Replies to reviews

“Towards robust seasonal streamflow forecasts in mountainous catchments: impact of calibration metric selection in hydrological modeling”

Diego Araya, Pablo A. Mendoza, Eduardo Muñoz-Castro and James McPhee

Figure 3. Flowchart describing the approach used in this study. See text for details.

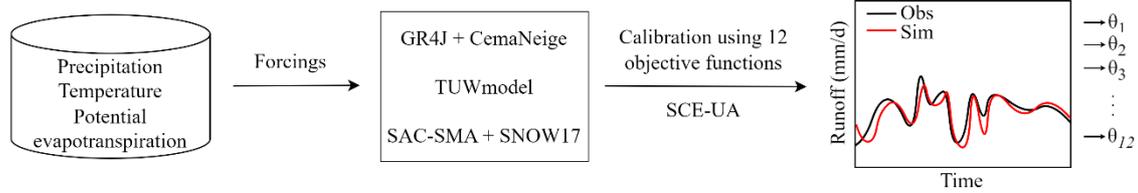
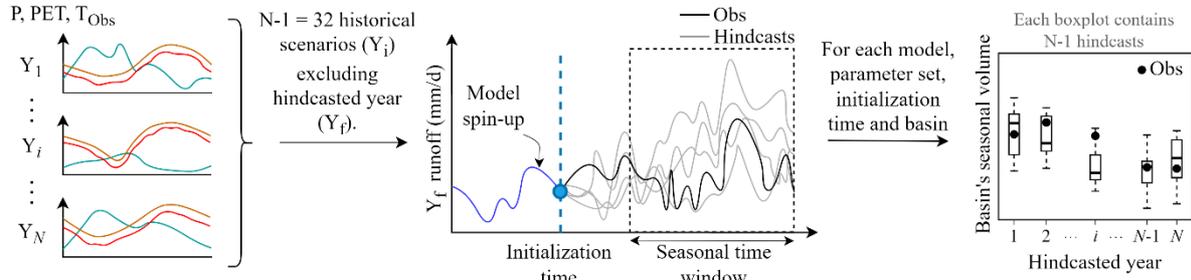
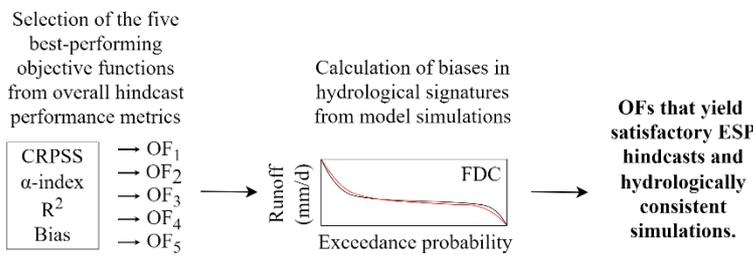
A detailed flow chart can be used to convey the method. Parts of the methodology are distributed across different sections, including the introduction.

We have designed a new and more detailed flow chart. Additionally, we have added a diagram inspired by Figure 3 in Crochemore et al. (2020) to explain the Ensemble Streamflow Prediction (ESP) method, which is now detailed in section 3.2 (L201-219).

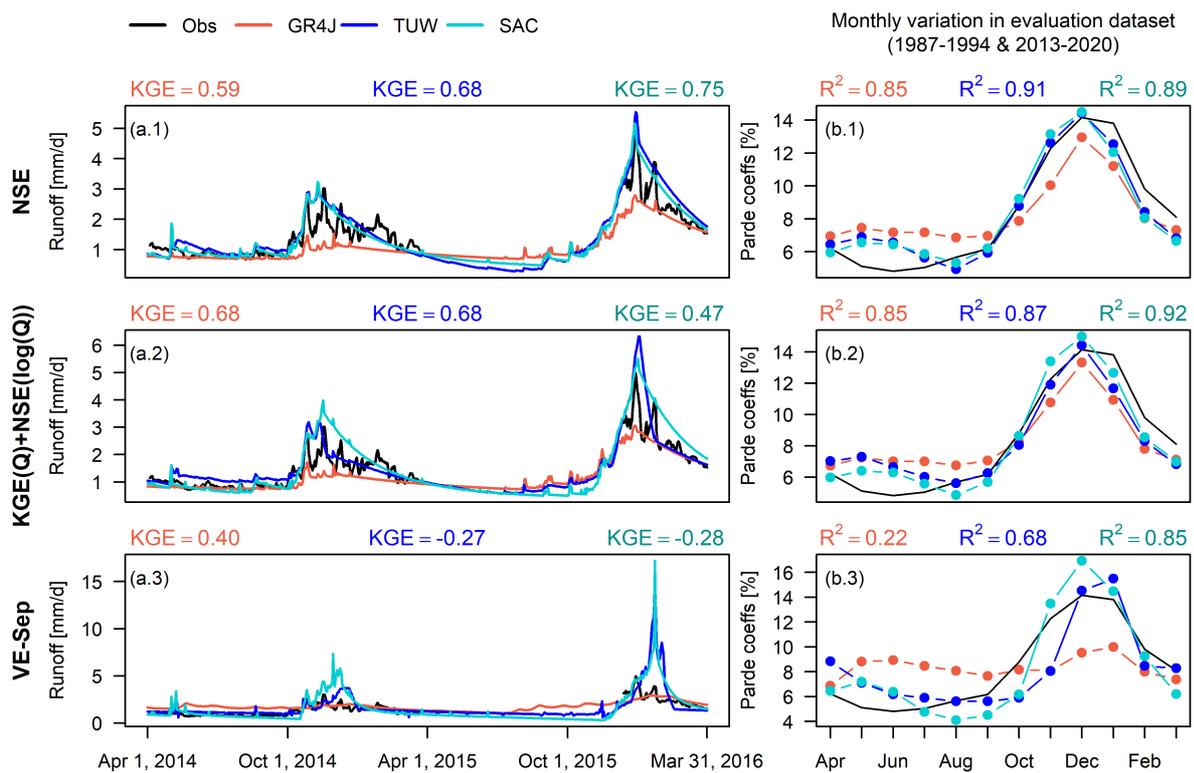
Similarly, I did not understand what the authors meant by the first and second validation periods in the Figure 8 caption. Did you mean the calibration period, where the model is calibrated using different parameters, and the hindcast period, where the ensemble streamflow prediction method is employed?

As pointed above, we have replaced the term “validation” by “evaluation”, which refers to the process of evaluating the quality of streamflow simulations outside the calibration period. Additionally, we have merged the originally proposed first and second evaluation periods into a single evaluation data set (which spans April/1987 – March/1994 and April/2013 – March/2020) to assess model simulations graphically and quantitatively. Such evaluation is illustrated for three objective functions in Figure 4 (former Figure 8). We clarify this procedure in Section 3.1.2 (L196-199):

“Model evaluation is conducted by computing performance metrics using data from two periods: (i) April/1987 - March/1994, which is hydroclimatically diverse, and (ii) April/2013 – March/2020, which is characterized by unprecedented and temporally persistent dry conditions (Garreaud et al., 2017, 2019). In both cases, the preceding 8-year period is used for model spin-up”.

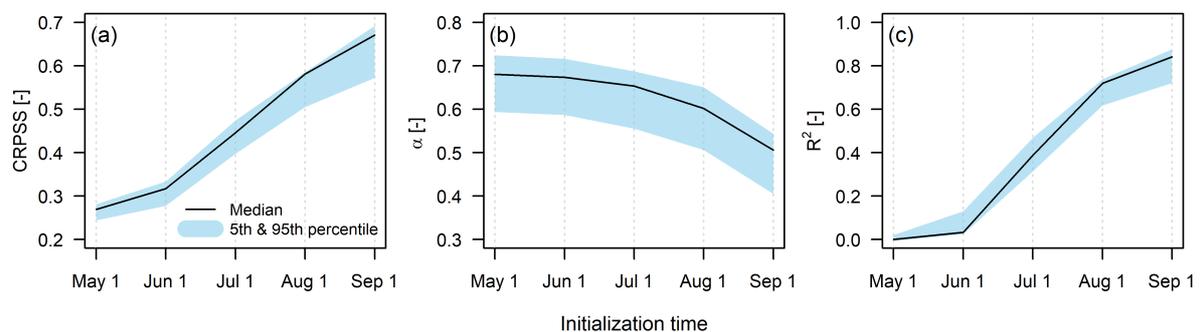
For instance, I would suggest focusing on the median result of all model combinations while showing the effect of initialization time and performance metrics for each calibration OF (Figure 7).

In response to the comments from Reviewers #1 and #2, we have redesigned Figure 7, showing three hindcast performance metrics and five initialization times from only one model structure (TUW), with parameters calibrated with only one objective function (NSE). We display the median (solid line) and the 5th & 95th percentiles from the 22 case study basin basins as a light-blue shade for each metric. The results presented in this figure communicate the same findings obtained for the remaining representative objective functions and models: CRPSS and R^2 (α -index) values increase (degrades) as hindcast initializations approach Sep. 1. We decided to keep all five initialization times to clearly show the progression of seasonal (i.e., September-March) hindcast quality during the austral winter. The extended version of the new Figure 6 (which contains all five representative objective functions) is now included in the Supporting Information document. We make all these points in section 4.2 of the revised manuscript (L296-303):

“Figure 7 illustrates how initialization time affects hindcast quality attributes when using NSE as calibration metric and the TUW model. As observed in the Upper Maipo River basin (**Error! Reference source not found.**), CRPSS and R^2 (the α index) improve (degrades) as hindcasts initializations approach September 1, with considerable increments in skill on July 1 compared to May 1 and June 1 hindcasts. The skill of May 1 hindcasts is rather low (with CRPSS 5th and 95th percentiles, obtained from the 22 catchments, equal to 0.26 and 0.28, respectively) and does not improve considerably on June 1. Additionally, inter-basin differences in CRPSS increase as hindcast initializations approach the beginning of the snowmelt season, ranging 0.57-0.69 on September 1. The same patterns, with small variations in ranges, are observed for the remaining representative objective functions and models (see Figures S7, S8 and S9 in Supporting Information).”

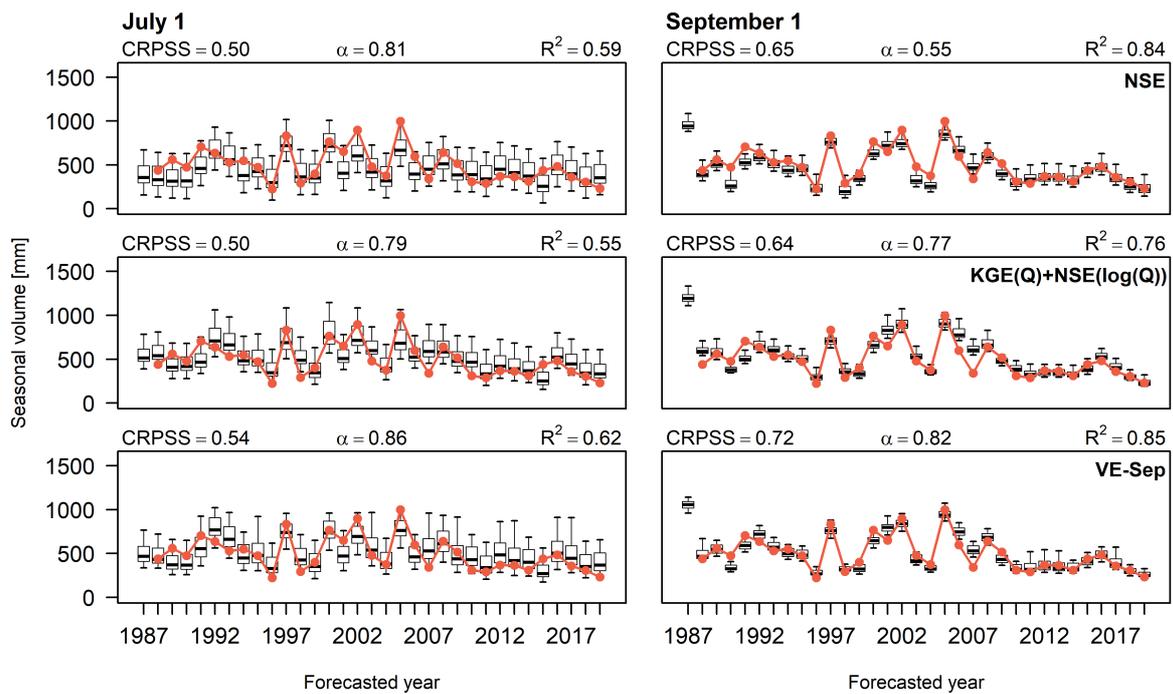
Fig. 5: to extend in height to enhance visualisation.

We have modified this figure (now Figure 6) following the reviewer's suggestion. We have also changed the colours to enhance visualization.

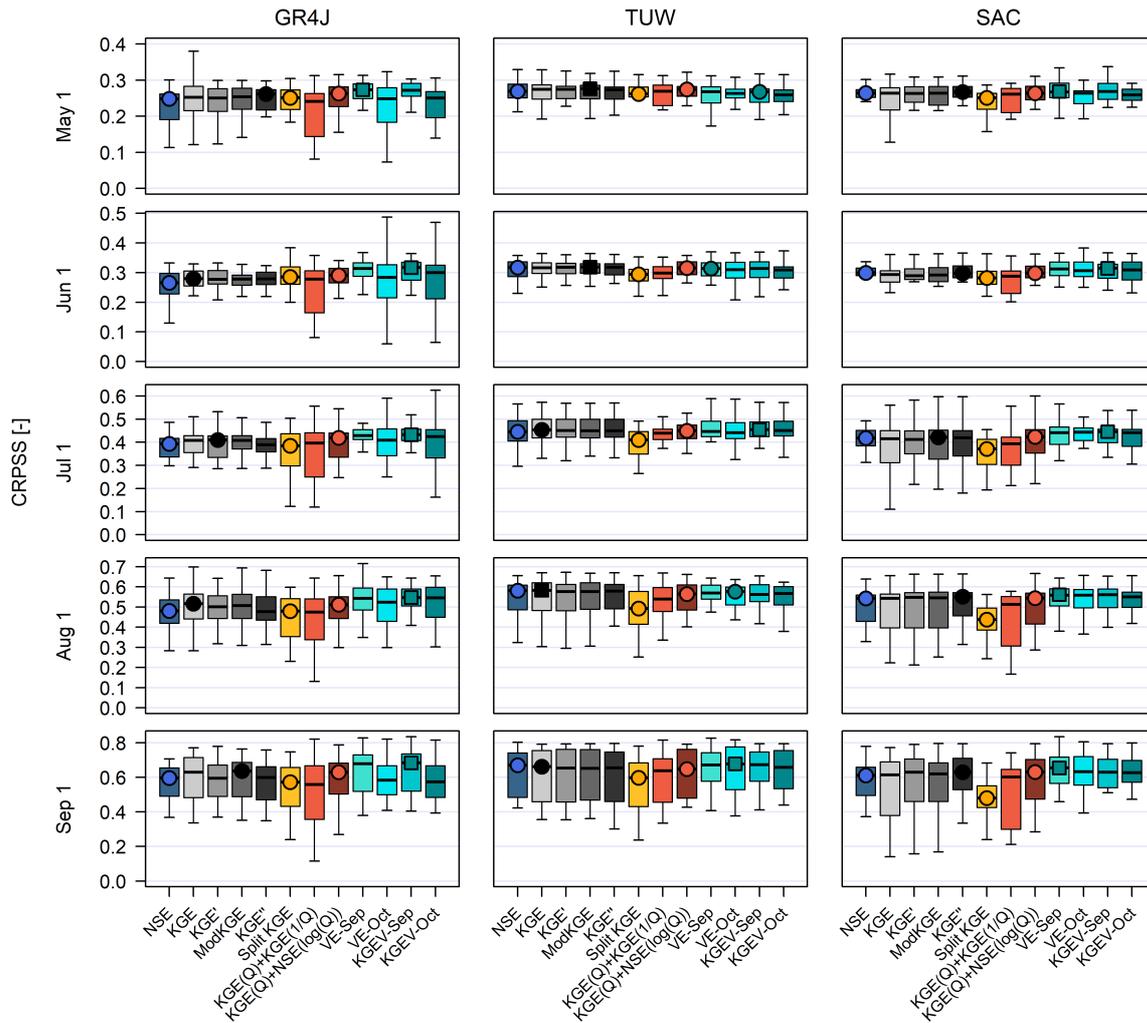
Fig. 6: to move to the supplementary materials.

We have moved this figure to the Supporting Information section (Figure S5), following the reviewer's recommendation.

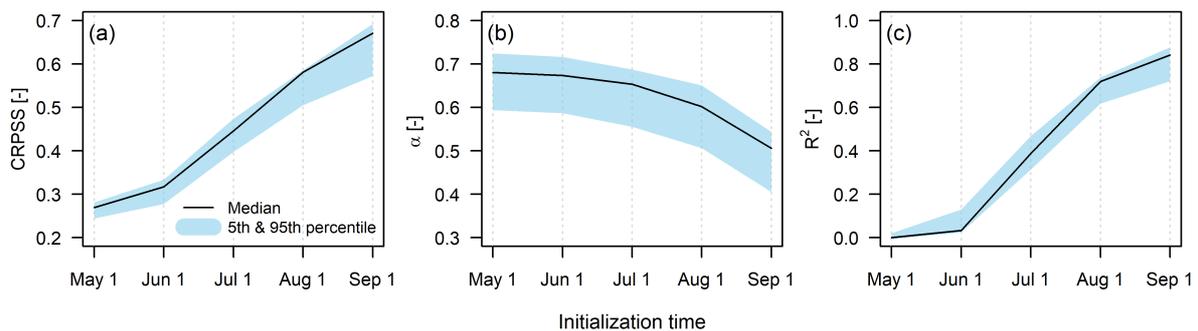
Fig. 7: show only three OFs (pick the most relevant to highlight your conclusions), May 1 and Sep 1 for initialization times and two forecast criteria.

In response to the comments from Reviewers #1 and #2, we have redesigned Figure 7, showing three hindcast performance metrics and five initialization times from only one model structure (TUW), with parameters calibrated with only one objective function (NSE). We display the median (solid line) and the 5th & 95th percentiles from the 22 case study basin basins as a light-blue shade for each metric. We believe that the results from one model and one calibration metric are enough to communicate the same findings obtained for the remaining representative OFs and models: CRPSS and R^2 (α -index) values increase (degrades) as hindcast initializations approach Sep. 1. We decided to keep all five initialization times to clearly show the progression of seasonal (i.e., September-March) hindcast quality during the austral winter. The extended version of the new Figure 6 (which contains

all five representative objective functions) will be included in the Supporting Information. We make all these points in section 4.2 of the revised manuscript (L296-303):

“Figure 7 illustrates how initialization time affects hindcast quality attributes when using NSE as calibration metric and the TUW model. As observed in the Upper Maipo River basin (**Error! Reference source not found.**), CRPSS and R^2 (the α index) improve (degrades) as hindcasts initializations approach September 1, with considerable increments in skill on July 1 compared to May 1 and June 1 hindcasts. The skill of May 1 hindcasts is rather low (with CRPSS 5th and 95th percentiles, obtained from the 22 catchments, equal to 0.26 and 0.28, respectively) and does not improve considerably on June 1. Additionally, inter-basin differences in CRPSS increase as hindcast initializations approach the beginning of the snowmelt season, ranging 0.57-0.69 on September 1. The same patterns, with small variations in ranges, are observed for the remaining representative objective functions and models (see Figures S7, S8 and S9 in Supporting Information).”

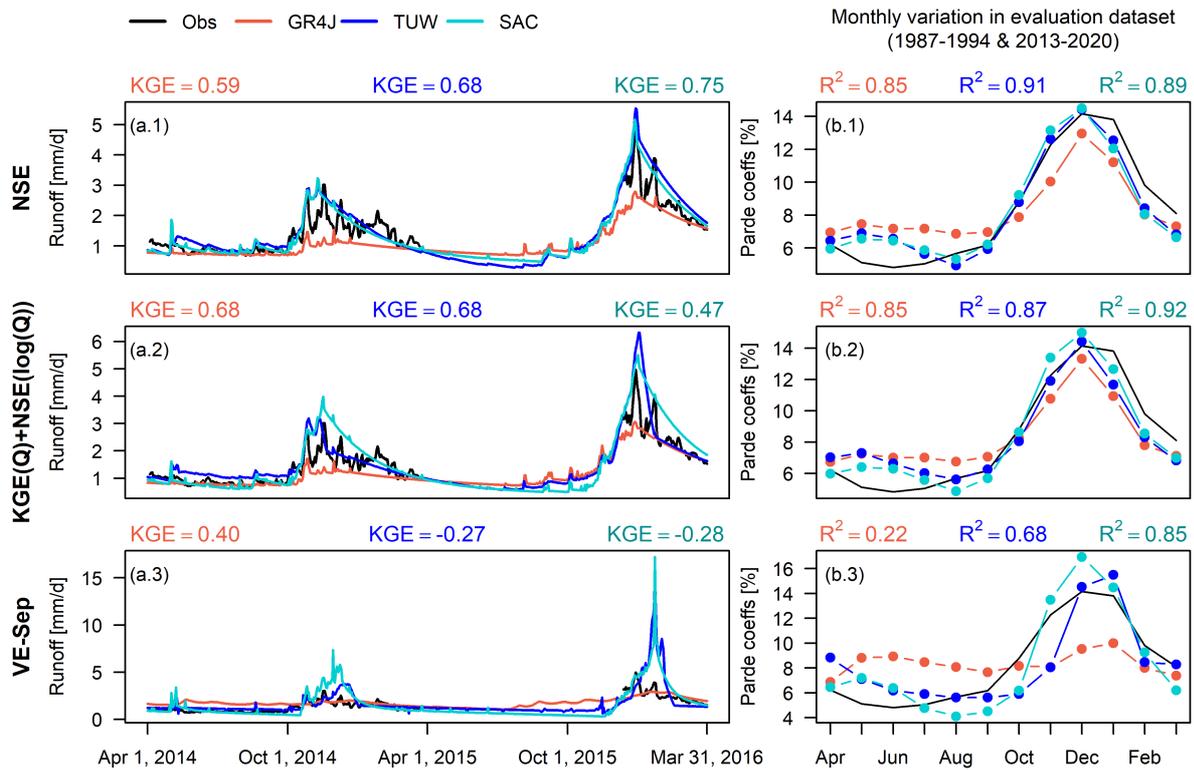
Fig. 8: keep only two OFs and present the daily hydrographs for two years in one of the validation periods.

In response to the recommendations provided by reviewers #1 and #2, we have merged the originally proposed first and second evaluation periods into a single evaluation data set (which spans April/1987 – March/1994 and April/2013 – March/2020). Hence, we show daily hydrographs for two water years from the evaluation data set, and the runoff seasonality curves are displayed jointly for these two periods. We decide to show results for three representative objective functions (the same as in Figure 5), and place this figure before.

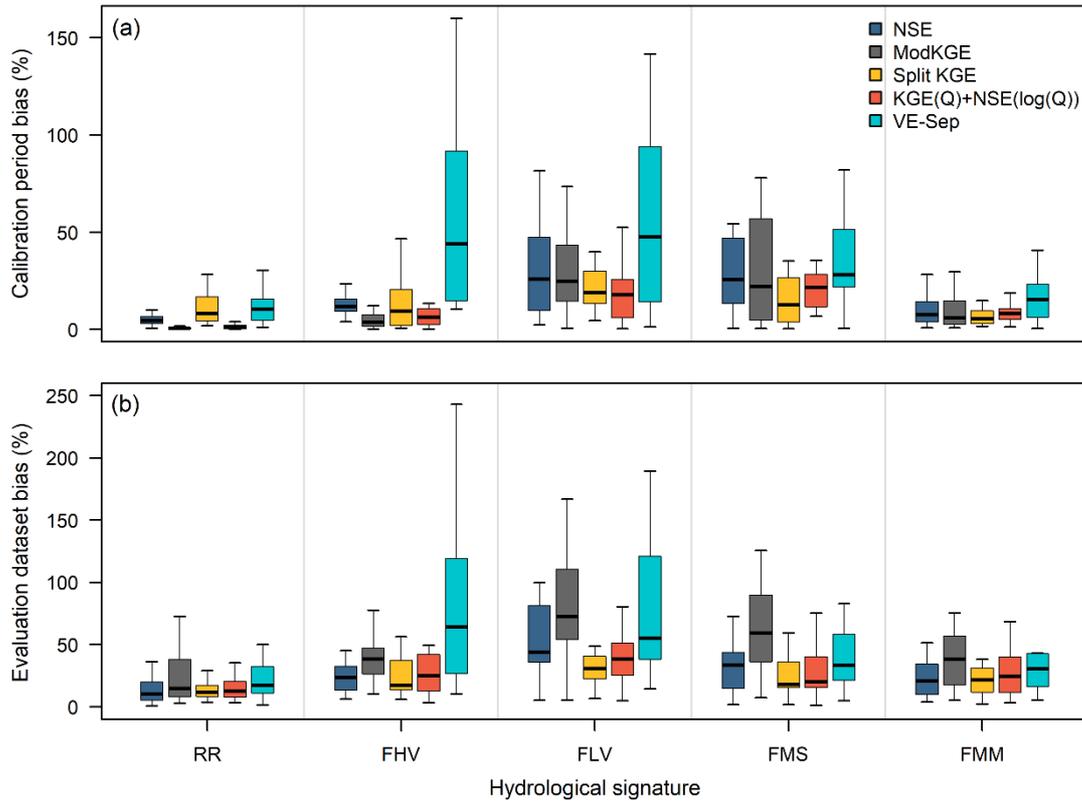
Fig. 9: keep only two or three OFs and extend the figure in height.

We have extended the figure (now numbered as Figure 8) in height and have simplified it by removing one of the signatures (F9M, since it contained very similar information of high flows than FHV), and showing the results from only one model (TUW). Nevertheless, we decided to keep the five representative objective functions for consistency with Figure 6, which highlights them as the best performing OFs per family. Additionally, we now show percent biases in hydrological signatures for the calibration period and for the combined evaluation data set, which combines the periods April/1987 – March/1994 and April/2013 – March/2020.

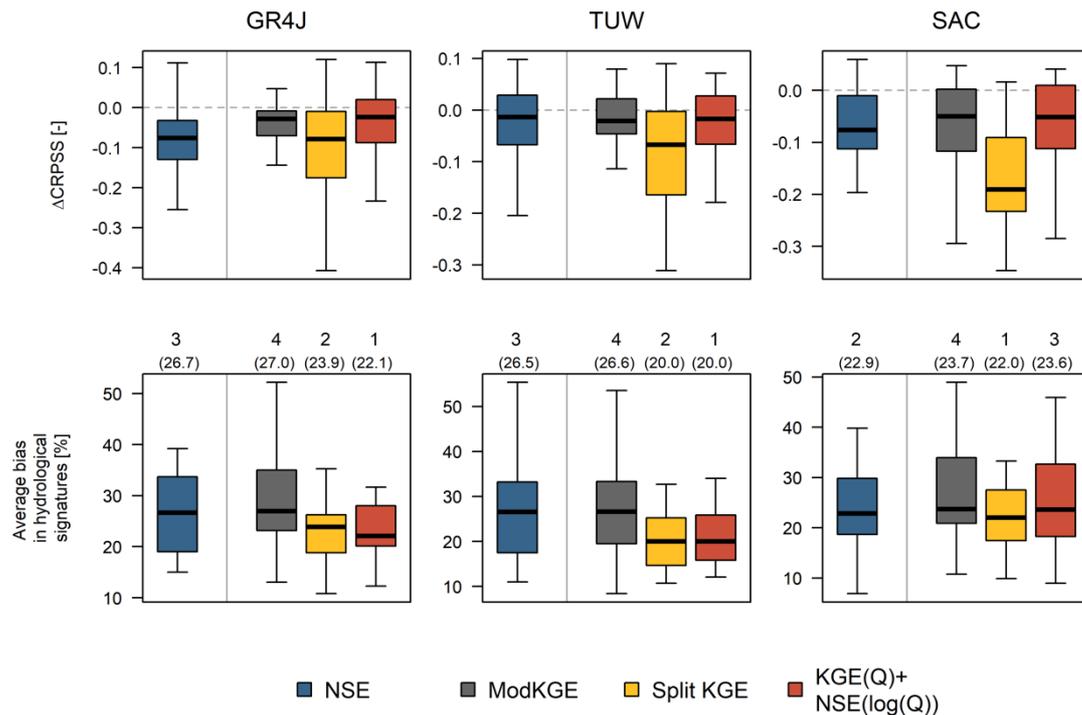
Fig. 10: remove the alpha and bias lines. Show only KGE or NSE for popular OFs.

We have modified this figure (now numbered as Figure 9) following the reviewer’s suggestion. We have also removed the results from the KGE(Q)+KGE(1/Q) objective function because it did not add any relevant information relative to what is illustrated with the remaining objective functions.

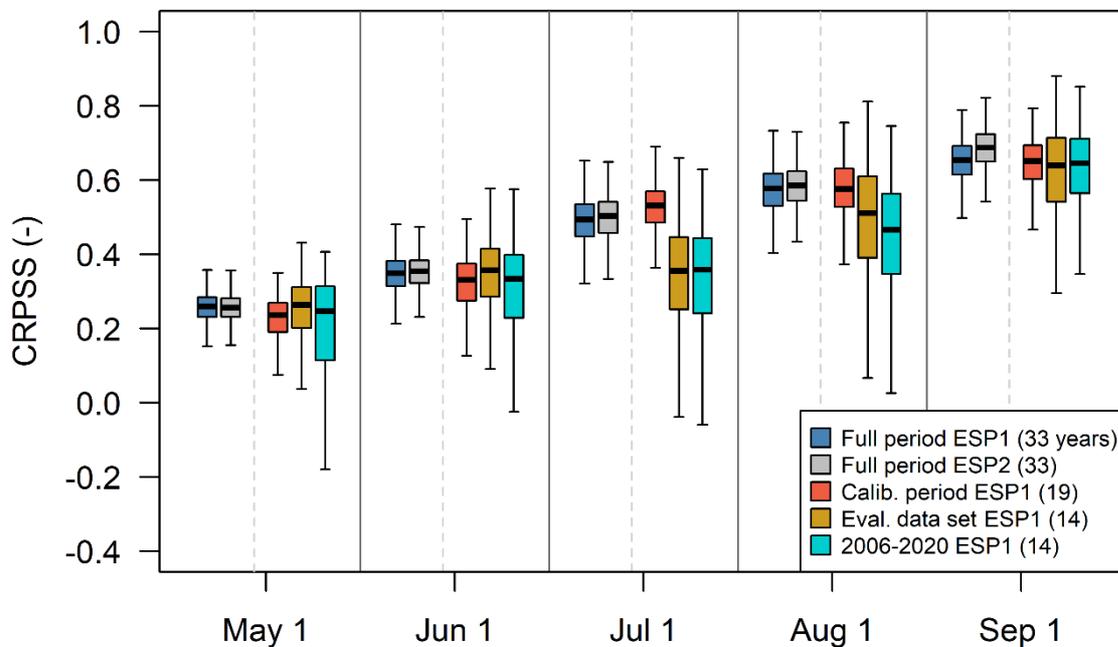
I did not understand why the ESP forecasts were evaluated on both calibration and evaluation periods without separation in the result analyses. Even if there are 32 meteorological inputs for each forecasted year, and that they are different from the meteorological input of the forecasted year, the streamflow data used to calculate seasonal performance has already been “seen” by the model during calibration. Since one of the goals of this study is to evaluate the impacts of calibration on seasonal forecasts, I think the authors should consider the evaluation of forecast quality only on the evaluation periods (or better explain why it was done that way). 33-1 years of meteorological data can still be used for the ensemble forecasts of each forecasted year. To improve the analysis of the hydrological consistency of model simulations, the authors could perform a split-sample test.

We agree with the reviewer in that, when the hindcasted year overlaps with the calibration period (as it happens with our experimental setup), the hydrological model gains information from meteorological inputs, even if the climate time series observed during that year are excluded from the generation of ESP hindcasts. In spite of this, we decided to take advantage of the entire 33-year period for hindcast verification, since small sample sizes (i.e., number of WYs) have been widely recognized as a serious limitation within the seasonal forecasting literature (e.g., Shi et al., 2015; Trambauer et al., 2015; Mendoza et al., 2017; Lucatero et al., 2018; Wood et al., 2018). This strategy enables a more robust assessment of seasonal hindcast quality, as opposed to using only the 14 WYs left for model evaluation. To demonstrate this point, we characterized the impact of sample size on the spread of CRPSS results by performing a bootstrap analysis with 1000 realizations for the Maipo River basin, using hindcasts produced with the TUW model and KGE(Q)+NSE(log(Q)) as the calibration metric (Figure 11). The analysis was conducted for the following verification samples: (a) full period (i.e., 33 WYs) using the same parameter set, obtained by calibrating the model with data from the period April/1994 – March/2013; (b) full period, using parameter sets re-calibrated with all data except the

hindcasted year (i.e., 33 parameter sets to produce 33 seasonal hindcasts); (c) 19 WYs (calibration periods), using a single parameter set obtained with data from the same period; (d) 14 WYs (i.e., evaluation data set April/1987 – March/1994 and April/2013 – March/2020), using the same parameter set as in case (c); and (e) 14 WYs (April/2006 – March/2020), using the same parameter set as in case (c).

The results in Figure 11 show a considerable spread in CRPSS arising from sampling uncertainty when using 14-year verification periods (orange and cyan boxes). Additionally, the median CRPSS results are lower than those obtained with 19 and 33 WYs in July 1, August 1 and September 1. An interesting result is the similarity of CRPSS values obtained with scenarios (a) and (b), suggesting that the hindcasting generation and verification approach adopted here (i.e., using a single parameter set obtained by calibrating will all the years with available observations) is a good proxy to characterize the hindcast quality that would be obtained with an operational setup that considers parameter re-calibration for each forecasted season.

We thank the reviewer for this thoughtful observation, and we have incorporated this analysis in the new section 5.5 (“Verification sample size”), contained in the discussion section (L421-441).
